## APPLICATION FOR PROPOSED ABLE MARINE ENERGY PARK

**CENTRICA PLC (UNIQUE REFERENCE NUMBER: [REDACTED]), KILLINGHOLME POWER STATION AND ASSOCIATED INFRASTRUCTURE, CHASE HILL ROAD, NORTH KILLINGHOLME AND CENTRICA STORAGE LIMITED, STATION ROAD, NORTH KILLINGHOLME**

## COMMENTS ON ABLE'S RESPONSE TO CENTRICA'S RELEVANT REPRESENTATIONS

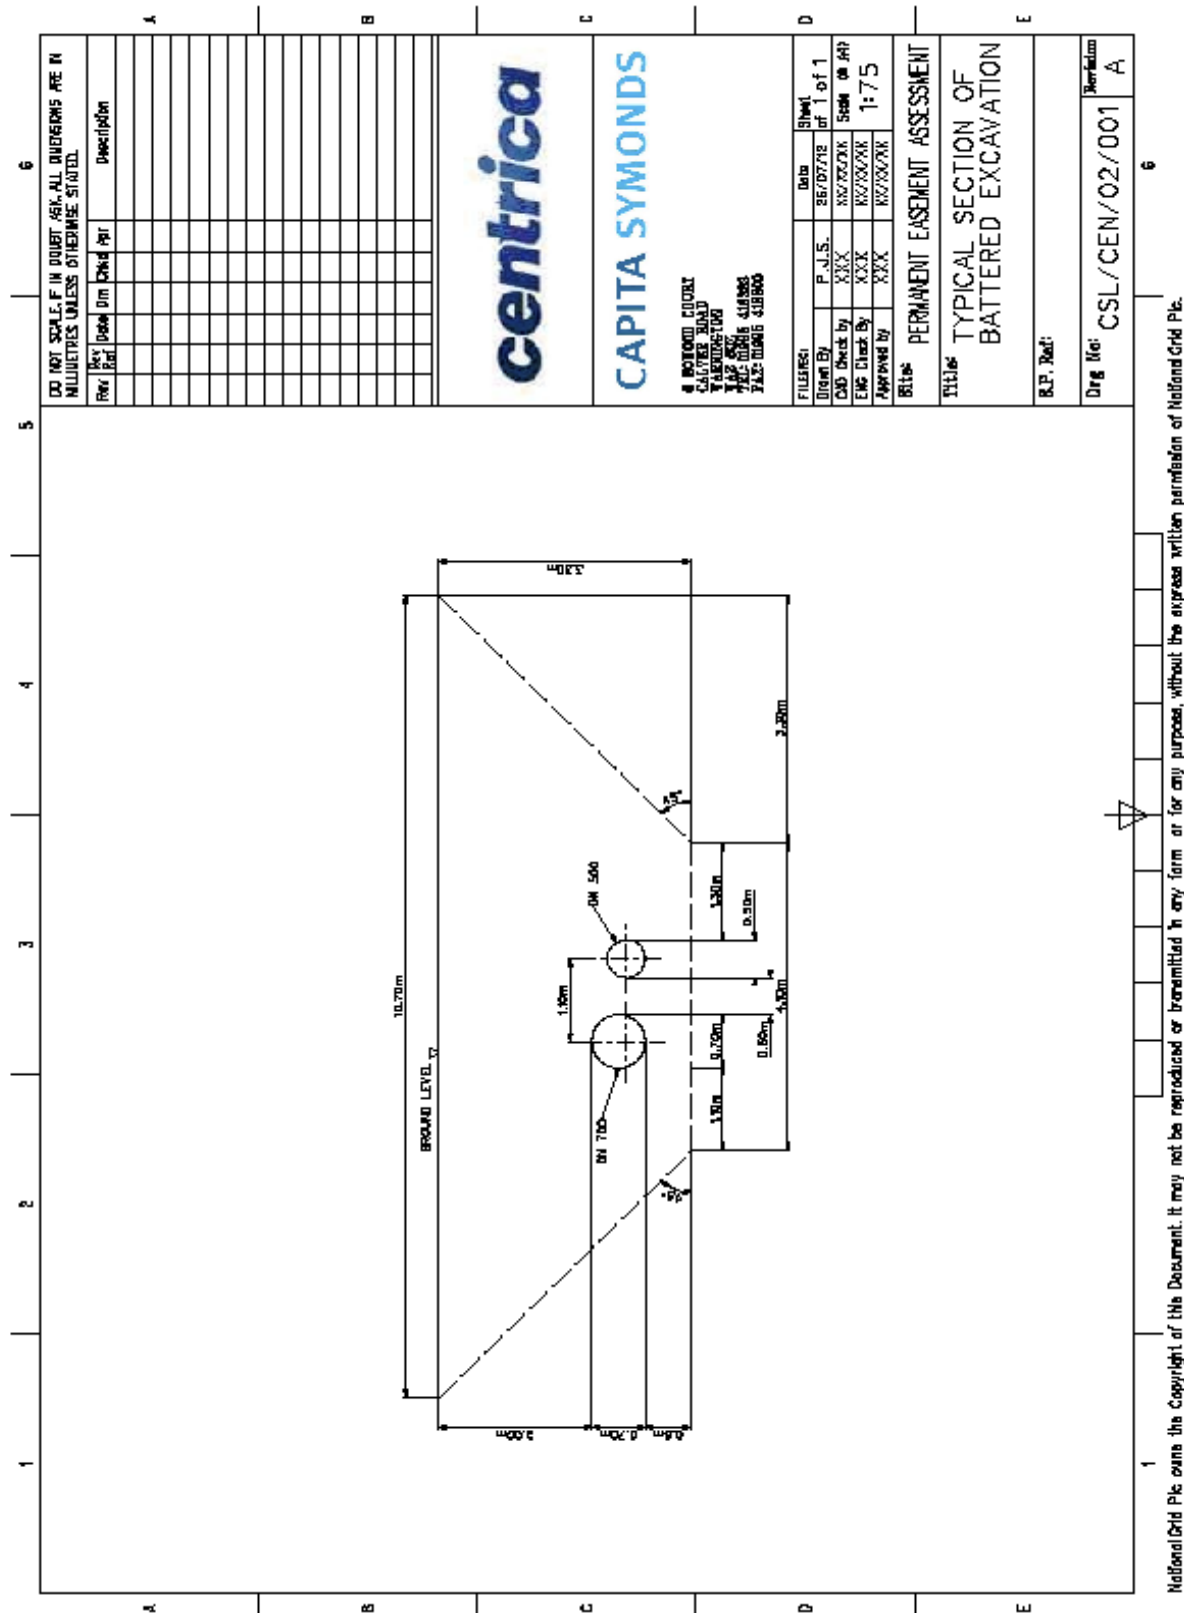
Drawing No. CSL/CEN/002/001 shows a depth to the invert from ground level of 3.3m. This is based on an original cover to crown (700mm pipe) of 2m plus pipe of 700mm plus clearance below pipe for working of 600mm. Using a safe angle of repose of 45 degrees the plan size at ground level of the battered excavation would be - width at bottom of excavation (4.1m) plus 2 x depth (2 x 3.3m) – **10.7m**.

In order to comply with the Working at Heights Regulations 2005 as amended by the Work at Height (Amendment) Regulations 2007 and to prevent overloading of the excavation a “safety zone” of 1m around the excavation should be included. A working area of 4m either side of the excavation would be required to allow for movement of plant, storage of equipment (including pumps) and maximising works above ground rather than in the excavation (this should be undertaken where ever possible to avoid the risks associated with working in an excavation – Working at Height Regs Section 6 (2)). Excavated material storage would need to be considered. The drawing below – CSL/CEN/02/002 shows the plan view of the required easement. As can be seen the preferred plan dimension for the easement would be **24.7m**.

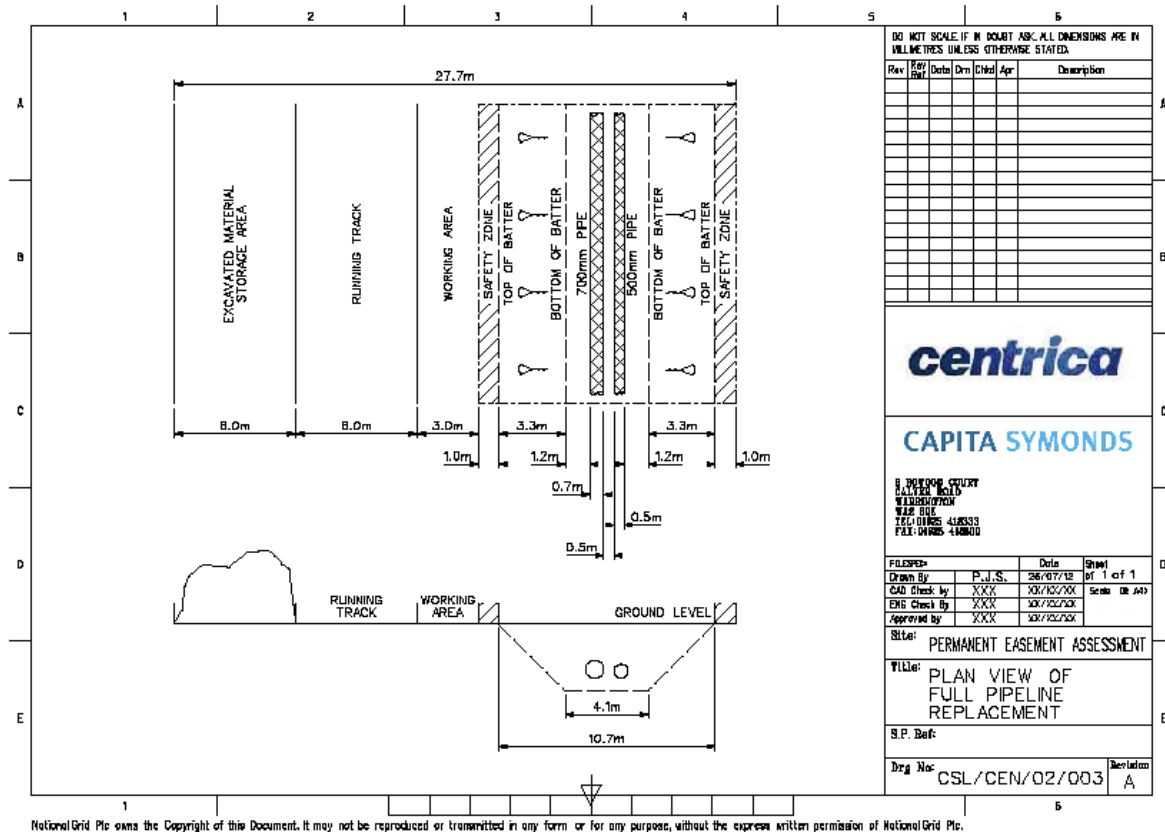
Option c) above – **Full length replacement of part or all of the existing buried services** - would require excavation works to be undertaken over the full length of the buried services. The preferred option would be a full working area as per Drawing No. CSL/CEN/002/003 below. This would take in to account the requirement for storage of excavated material along the full length of the corridor as well as having a safe working area for jointing of the new pipes above ground. This would result in an easement of **27.7m**.

### **Ground support / Shoring Option**

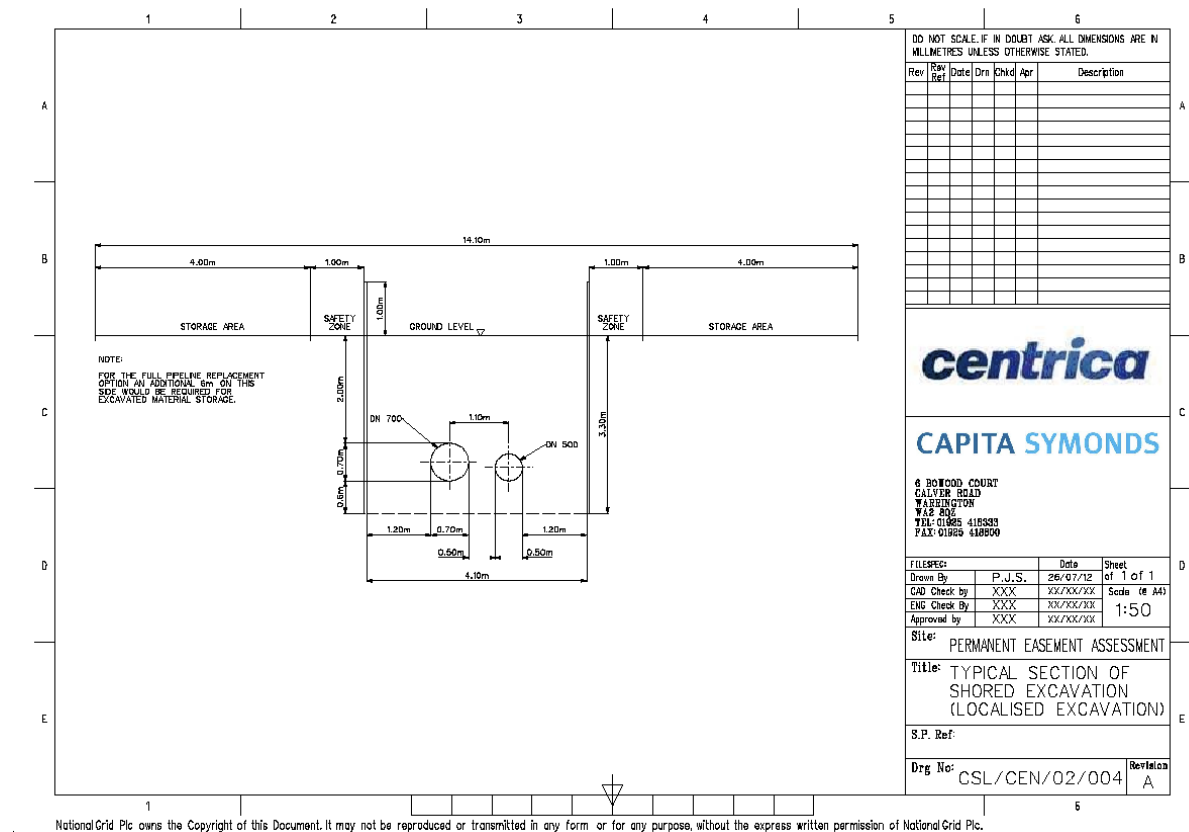
The use of shoring could be considered to reduce the plan size of the excavation. This would be a more expensive option (upwards of 40 – 50% increase in excavation costs) and would require a greater temporary works design but one that would lend itself to “localised” excavations. The “safety zone” and storage areas would still need to be considered. The use of shoring would result in reducing the easement area to **14.1m** for “localised” excavations. However for a full pipeline replacement option, additional storage areas for excavated material would need to be available. This would result in an easement of **20.1m**. Drawing CSL/CEN/02/004 below shows the typical section using trench shoring.

The shored trench solution would require horizontal beams/struts across the excavation to support the shoring. This creates an obstruction when considering the movement of labour, plant, equipment and materials within the excavation. For localised repairs it may be possible to design / plan for the positioning of these cross excavation supports such that they do not present an hazard or hinder the works. However with the full length replacement scenario these supports will present a problem to the workforce that will need careful consideration. Factors such as movement of workforce along the excavation, the lifting of plant and equipment in / out of the excavation and the lifting in / out of materials such as new sections of pipe will need to be factored. The risk of striking the cross excavation supports and therefore affecting the stability of the shoring system will need to be carefully managed.

**Figure 10a** Model predicted changes to morphology along a transect through the Centrica outfall (245 m chainage) and extending to the intake (about 300 m chainage) (each iteration corresponds to approximately six weeks duration)

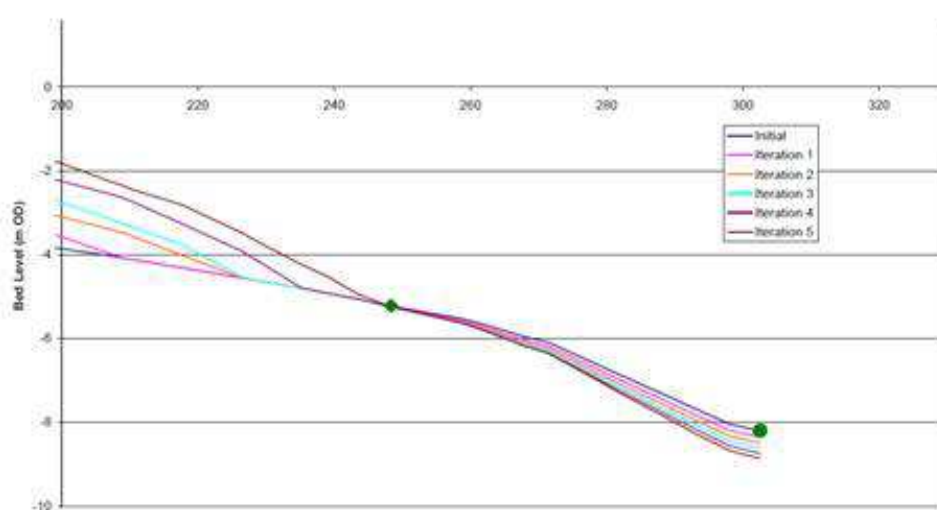
- If the 3D morphological modelling results are accepted then a range of questions arise that need addressing, including:
  - What are the full implications of erosion at the intake – ultimately there will come a point where the integrity of the infrastructure or its foundations are threatened.

[I do not see how these conclusions have been drawn – Figs 4 - 8 show progressive accretion between timesteps – none show any erosion so why does Fig 10a show erosion at the intake?]
